SUBJECT: CALVERT CLIFFS NUCLEAR POWER PLANT, UNITS 1 AND 2 - STAFF
ASSESSMENT OF INFORMATION PROVIDED PURSUANT TO TITLE 10
OF THE *CODE OF FEDERAL REGULATIONS* PART 50, SECTION 50.54(f),
SEISMIC HAZARD REEVALUATIONS FOR RECOMMENDATION 2.1 OF THE
NEAR-TERM TASK FORCE REVIEW OF INSIGHTS FROM THE FUKUSHIMA
DAI-ICHI ACCIDENT (TAC NOS. MF3970 AND MF3971)

STAFF ASSESSMENT BY THE OFFICE OF NUCLEAR REACTOR REGULATION

RELATED TO SEISMIC HAZARD AND SCREENING REPORT

CALVERT CLIFFS NUCLEAR POWER PLANT, UNITS 1 AND 2

Figure 3.3-1 Plot of NRC Staff and Licensee's Base Case Shear-Wave Velocity Profiles for the Calvert Cliffs site

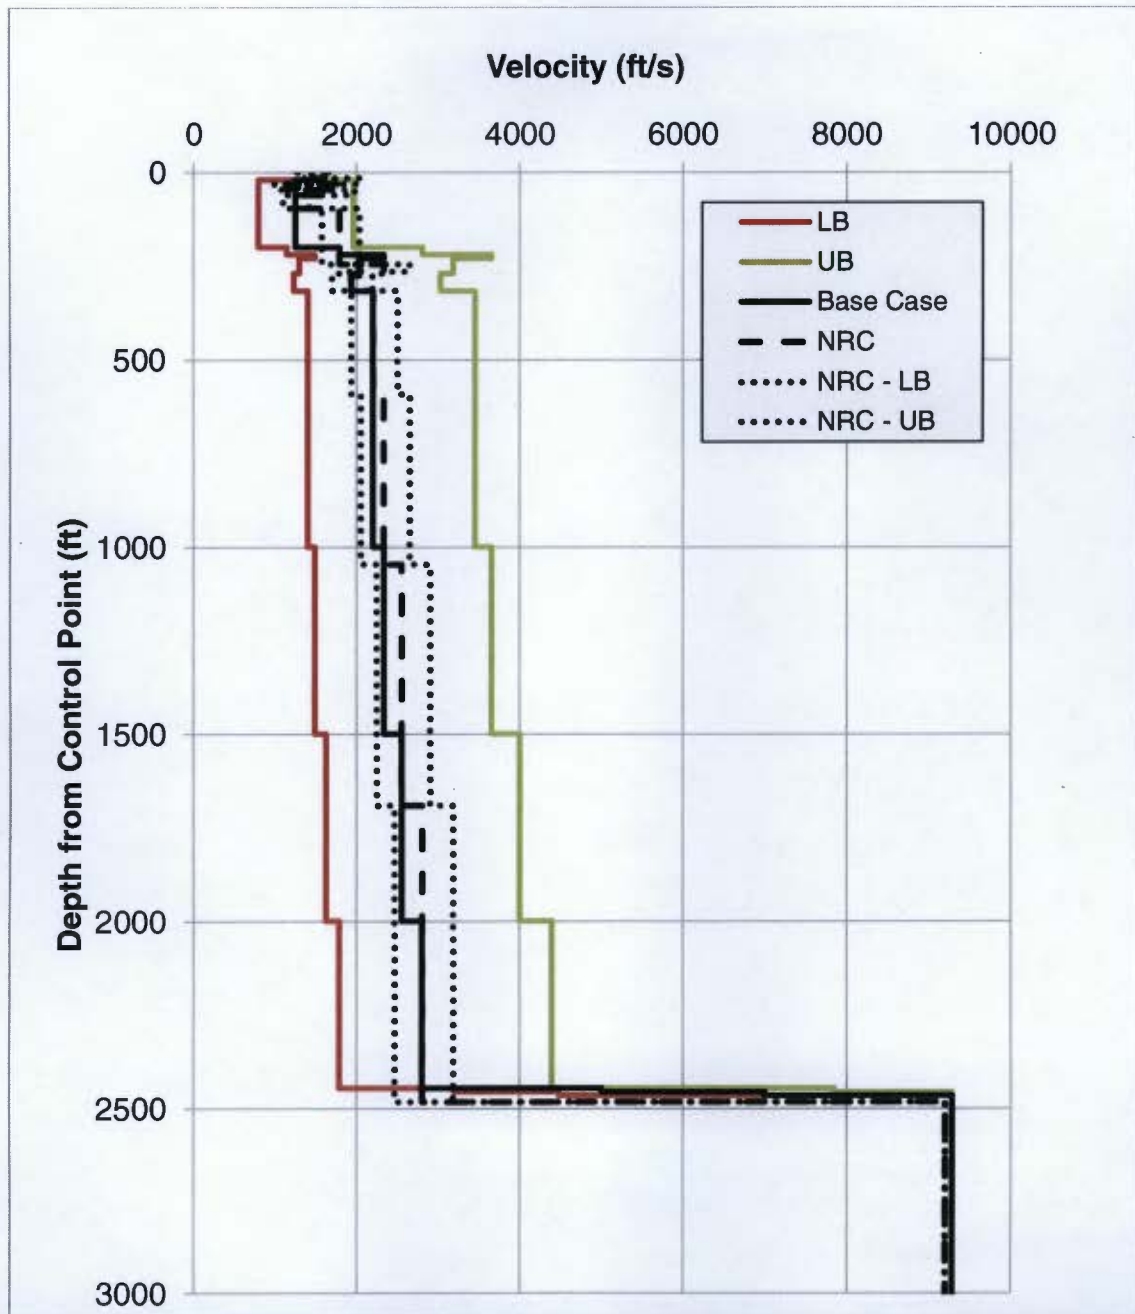
Overall, the staff's velocity profiles are similar to those developed by the licensee. Similar to the licensee, the staff also used the SPID guidance in developing the appropriate dynamic properties by using the appropriate EPRI soil and Peninsular curves. The staff's model, however, assumed a linear response below a depth of 360 ft [110 meters] whereas the licensee assume a linear response below a depth of 500 ft [152 meters]. For the site kappa values, the staff also estimated a value above 0.04 s and therefore, used a kappa value 0.04 s to be consistent with the SPID guidance.

Figure 3.3-2 Plot Comparison of the NRC Staff and the Licensee's Median Amplification Functions and Uncertainties for the Calvert Cliffs site

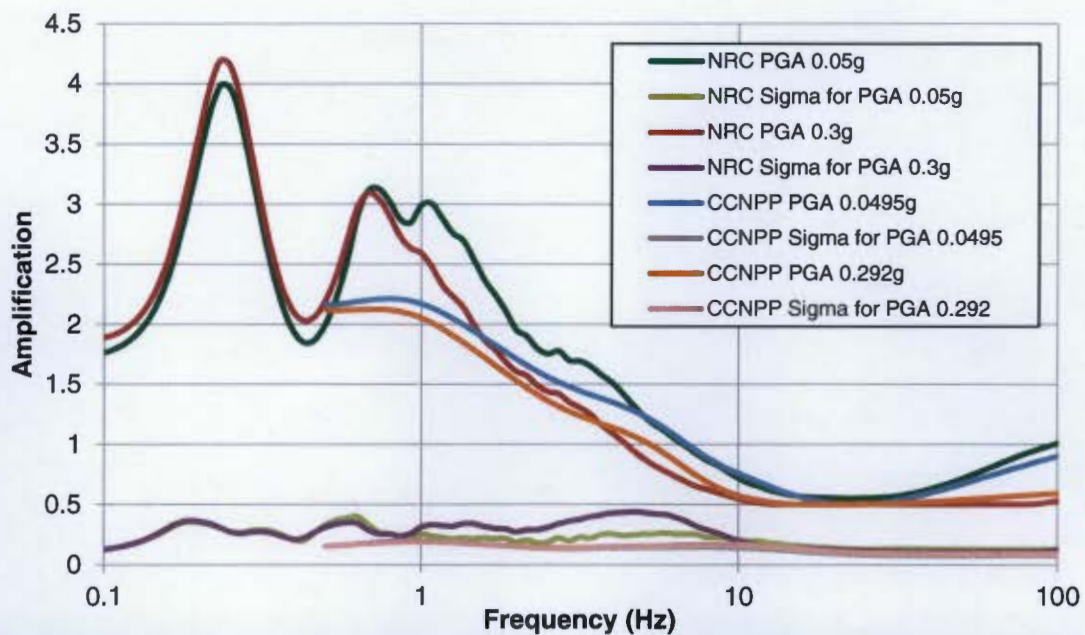
Figure 3.3-2 of this assessment shows a comparison of the staff's and licensee's median site amplification functions and uncertainties (± 1 standard deviation) for two of the eleven input loading levels. Even though there are some variations in site amplifications due to differing input model parameters, as shown in Figure 3.3-3 of this assessment, these differences do not impact the final control point hazard curves. Appendix B of the SPID provides guidance for performing site response analyses, including capturing the uncertainty for sites with less subsurface data; however, the guidance is neither entirely prescriptive nor comprehensive. As such, various approaches in performing site response analyses, including the modeling of uncertainty, are acceptable for this application.

Figure 3.3-3 Plot Comparison of the NRC staff and the Licensee's Mean Control Point Hazard Curves at a Variety of Frequencies for the Calvert Cliffs site

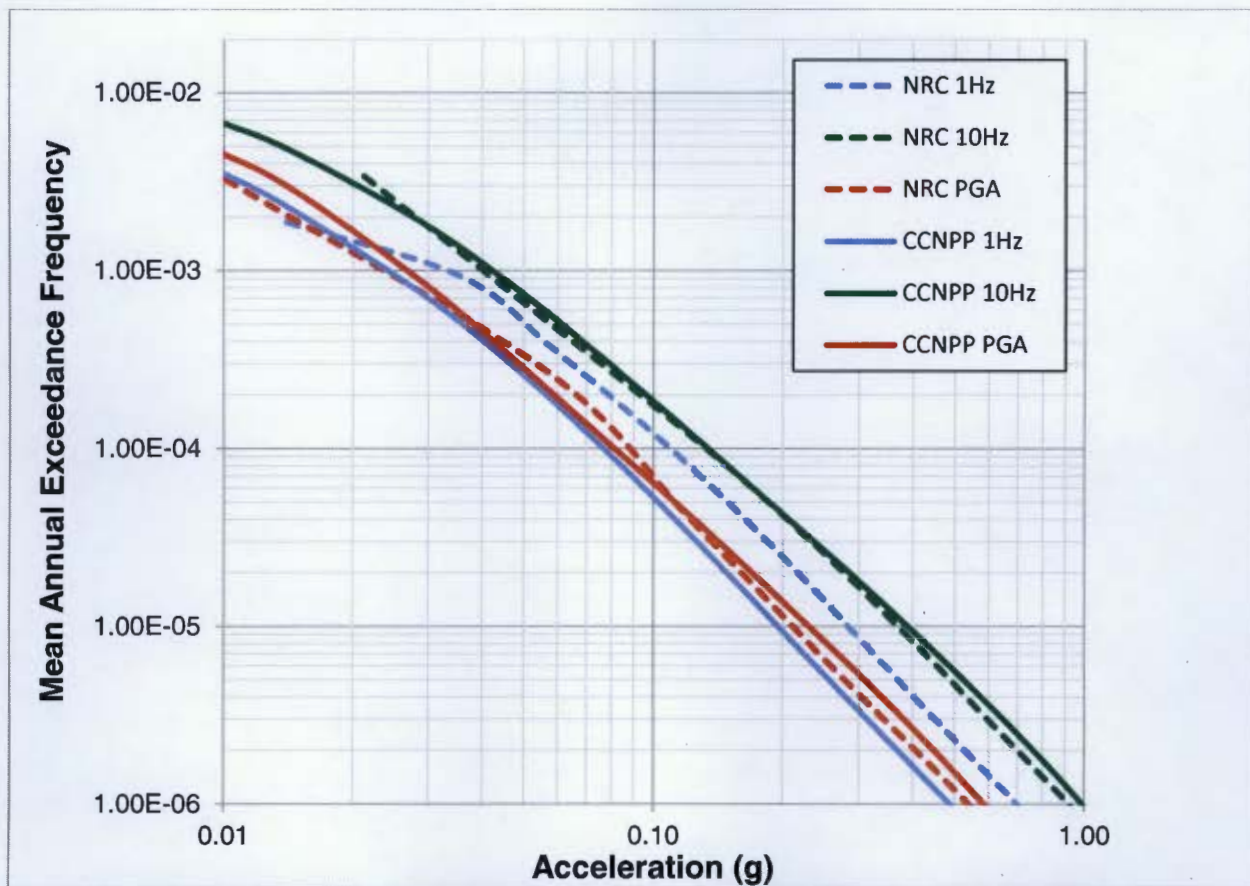
In summary, the staff concludes that the licensee's site response was conducted using present-day guidance and methodology, including the NRC-endorsed SPID. The staff performed independent calculations which confirm that the licensee's amplification factors and control point hazard curves adequately characterize the site response, including the uncertainty associated with the subsurface material properties, for the CCNPP site.

Figure 3.4-1 Comparison of the NRC staff GMRS with Licensee's GMRS and the Unit Nos. 1 and 2 SSE for the Calvert Cliffs site

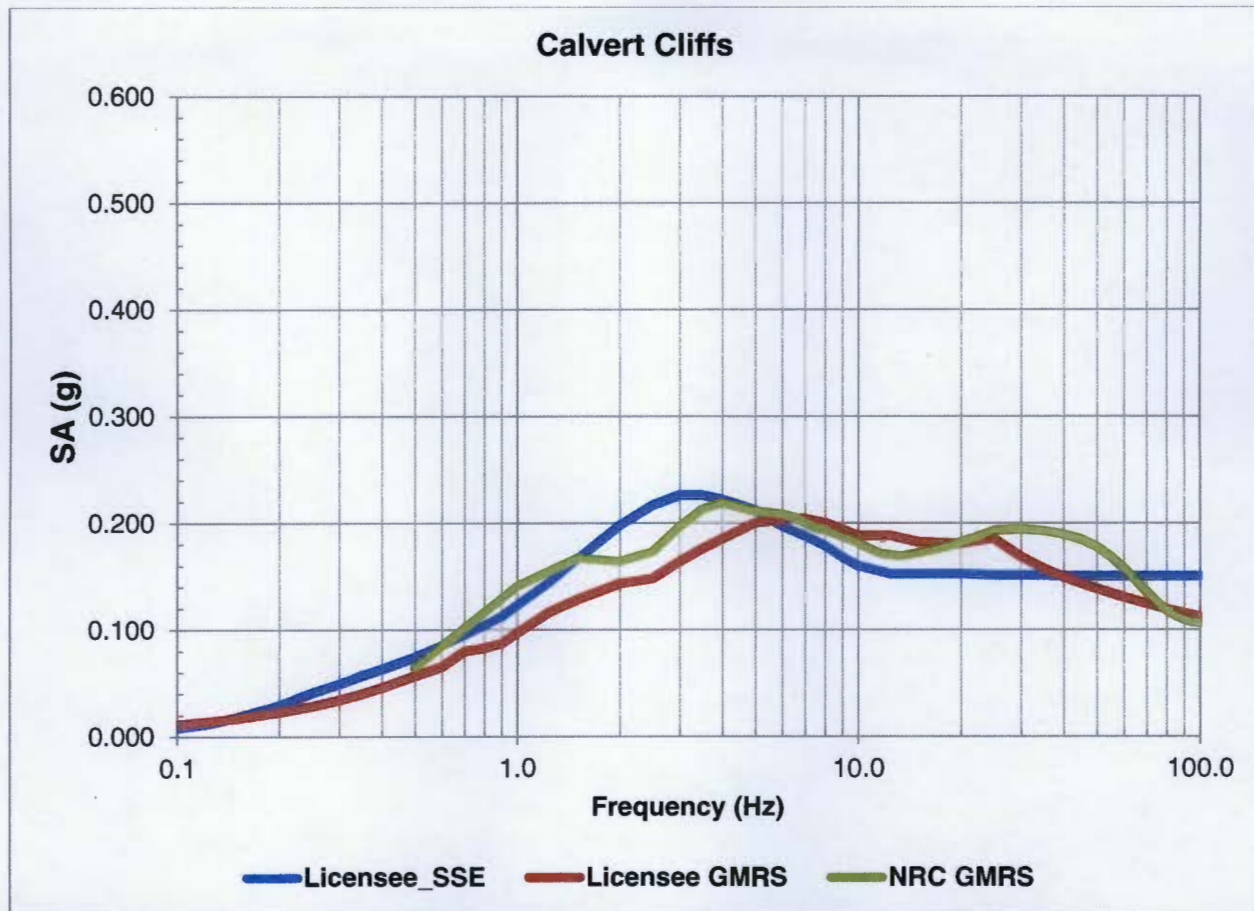
The staff independently calculated the 10^{-4} and 10^{-5} UHRs using the results of its confirmatory PSHA and site response analyses, as described in Sections 3.2 and 3.3 of this staff assessment, respectively. Figure 3.4-1 of this assessment shows a comparison of the GMRS determined by the licensee to that determined by the staff. As shown in Figure 3.4-1, the NRC's GMRS shape is generally similar to the licensee's GMRS across the entire frequency range.

The staff confirms that the licensee used the present-day guidance and methodology outlined in RG 1.208 and the SPID to calculate the horizontal GMRS, as requested in the 50.54(f) letter. The staff performed both a PSHA and site response confirmatory analysis and achieved results consistent with the licensee's horizontal GMRS. As such, the staff concludes that the GMRS determined by the licensee adequately characterizes the reevaluated hazard for the CCNPP site. Therefore, this GMRS is suitable for use in subsequent evaluations and confirmations, as needed, for the response to the 50.54(f) letter.
